TITLE: FireFly Controller FFC3232 -- MCU		REV: 2603
P5 Software	Company: P5 Software, LLC	Sheet: 1/9
	Date: 2026-02-21	Drawn By: B.A. Hendricks

Changes made since rev 2211

TITLE: FireFly Controller FFC3232 -- Notes		REV: 2603
P5 Software	Company: P5 Software, LLC	Sheet: 9/9
	Date: 2026-02-21	Drawn By: B.A. Hendricks

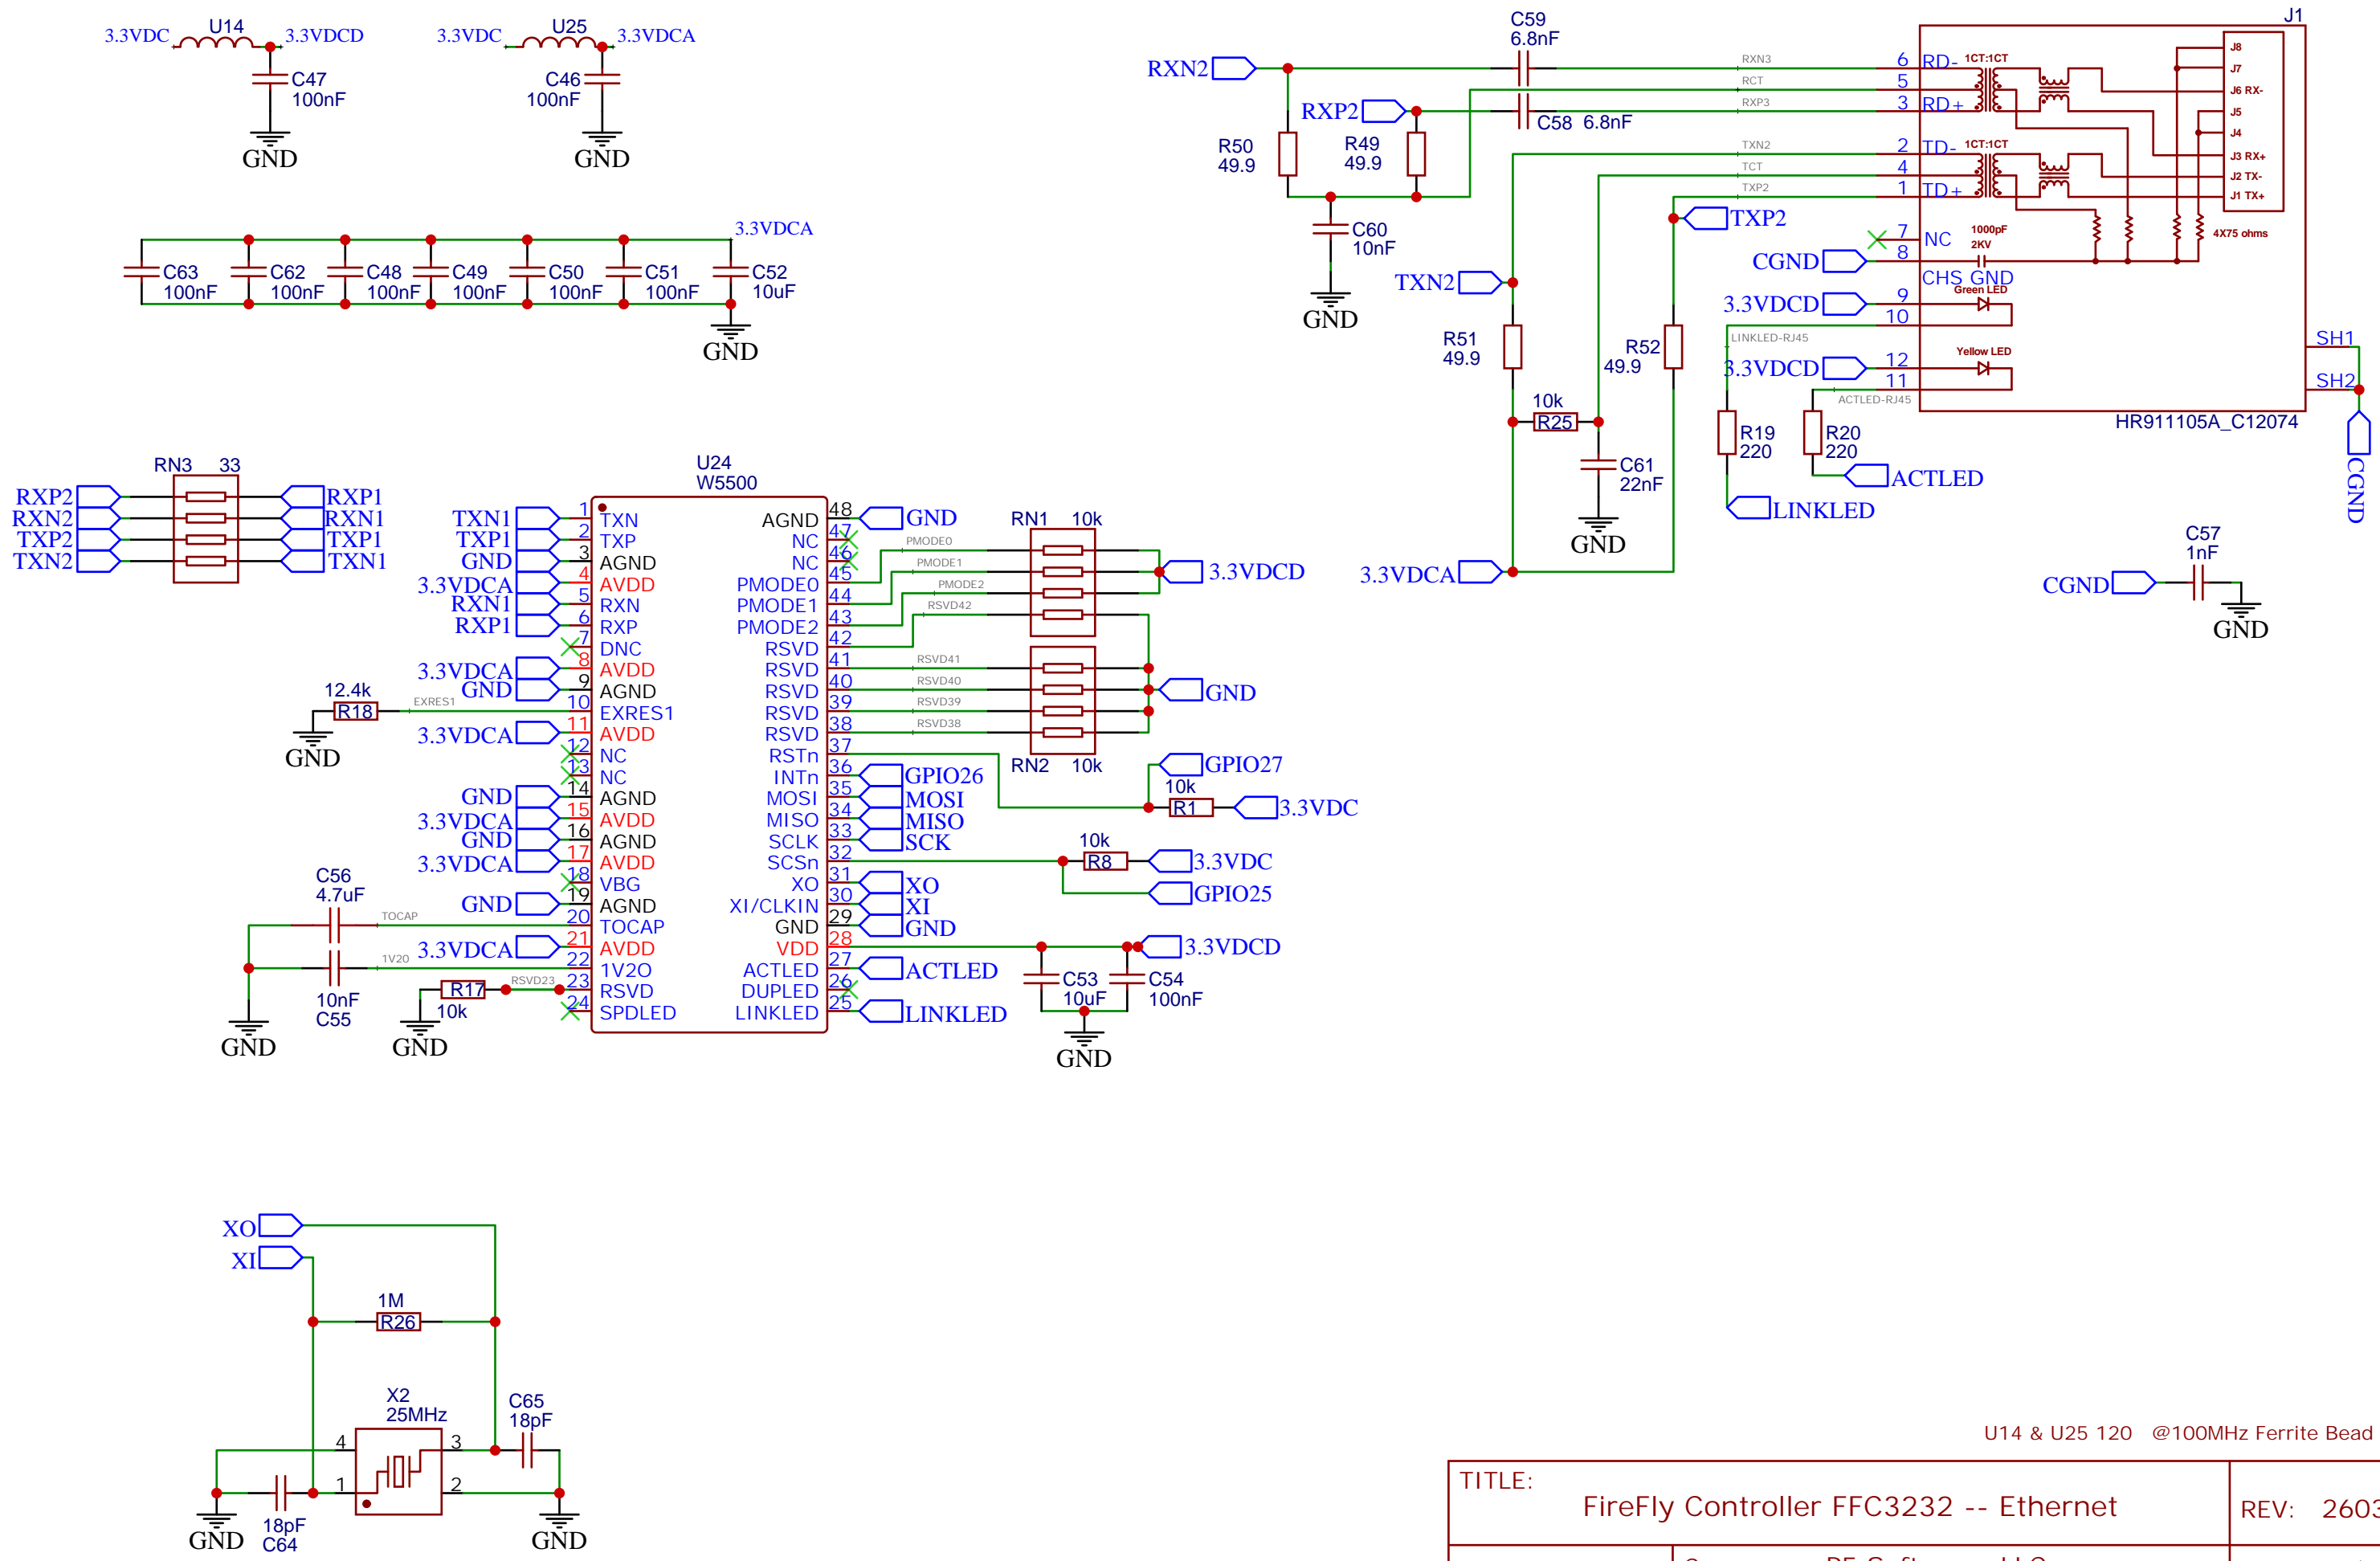
15. GPIO4 no longer used for PCA9555 interrupt (U7); now unassigned/available
16. Moved front panel button from GPIO32 to GPIO15
17. Moved front panel button LED from GPIO33 to GPIO2

22. Corrected MCU (U11) from ESP32-WROVER-E-N4R8 (C967023) to ESP32-WROVER-E-N16R8 (C529589)
23. Removed 9VDC power system; System will use 12VDC for all client and relay outputs directly from the external power supply

TITLE: FireFly Controller FFC3232 -- Ethernet		REV: 2603
P5 Software	Company: P5 Software, LLC	Sheet: 2/9
	Date: 2026-02-21	Drawn By: B.A. Hendricks

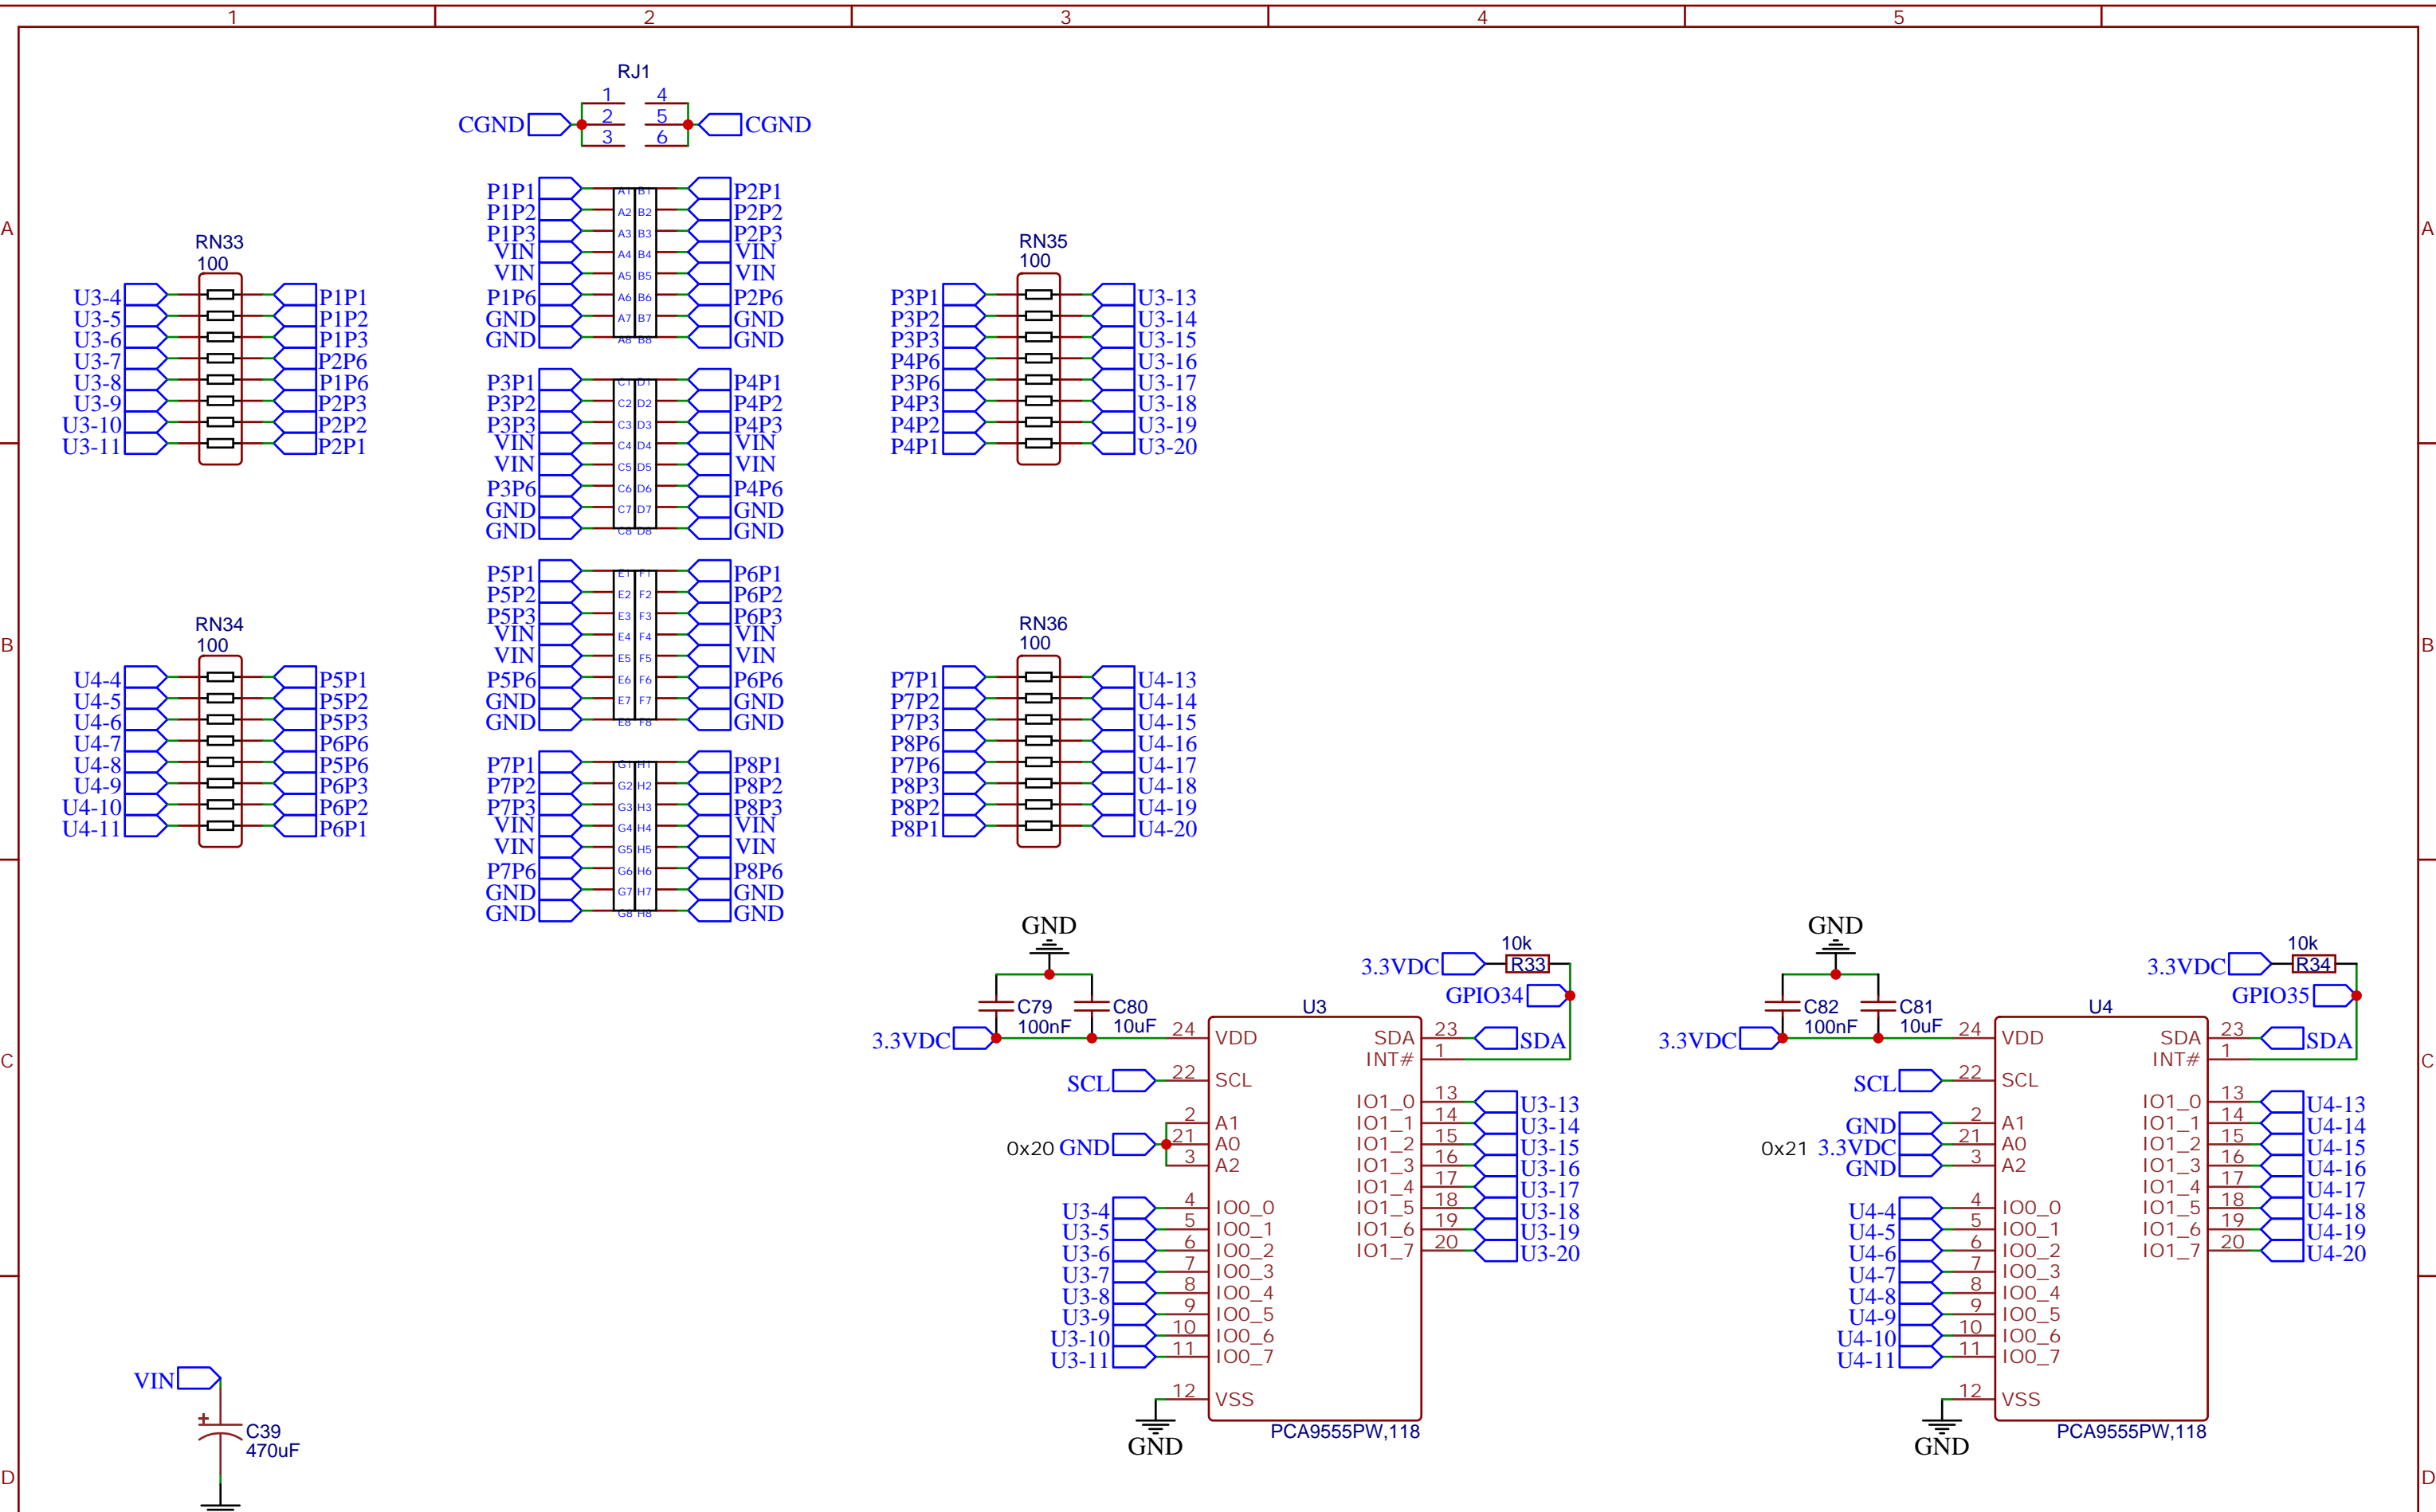
18. Changed U24 (W5500) RSTn from being constantly pulled high to being pulled high with 10k resistor and connected to GPIO27
19. Changed U24 (W5500) INTn from being disconnected to being connected to GPIO26

20. Changed U24 (W5500) SCSn from being connected to GND to being pulled high with 10k resistor and connected to GPIO25
21. Improved power conditioning for Ethernet: added LC filter and bulk/decoupling caps on W5500 3.3V analog rail
